## OICA comments on EFV-08-06

### Parameter: Noise

EFV 07-05: Noise

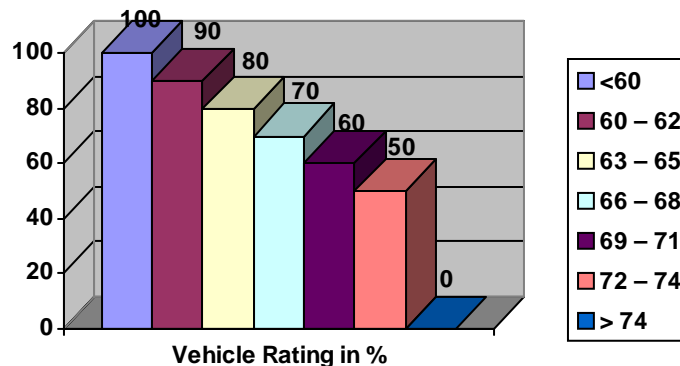
Noise regulations put stringent requirements on road vehicle noise emission. Environmental noise, caused by traffic, is considered to be a significant local environmental problem in world. It is estimated that millions of people suffer from noise levels that scientists and health experts consider unacceptable. The vehicle fleet noise has not changed very much over the last three decades; however, if the trend in hybrid vehicle use continues, substantial noise reduction will occur (*The dominating noise source in traffic is tyre/road noise, which is not dependent from the power source of the vehicle. Thus the positive effect for noise of electrified vehicles is limited.*).

have minimum noise level to ensure the pedestrian’s safety. *(This is actually under research. It is premature to conclude the need of minimum noise standards. However an EFV should not endanger pedestrians.)*

From the reviews of 7<sup>th</sup> Informal Group Meeting of Environmentally Friendly Vehicle, held in Geneva in conjunction with 60<sup>th</sup> GRPE session, the 60 dB value specified for the quietest vehicle was the matter of debate. It is agreeable with the experts that the 64 ~ 65 dBA value can be the best value for the noise rating. But the thing is about achieving more and more stringent and future norms, by reducing the noise levels. On the other hand the 64 ~ 65 dBA value has not been outlined, but has given the weightage of 80 %. So it will be the goal set for the manufacturers to achieve lower and lower noise values. *(This should be discussed in GRB. To review the actual state-of-the-art noise emission of vehicles, please consider ECE-TRANS-WP29-GRB-52-inf07e - page 19)*

This scope of EFV is limited to passenger cars M1. Presently noise level as per the ECE R 51 is 74dB (A), which is same in India also. *(Currently the whole test standard is under revision and the new type approval test method B will come to application soon and replace the actual type test method. A classification for EFV should be based on the new test method.)*
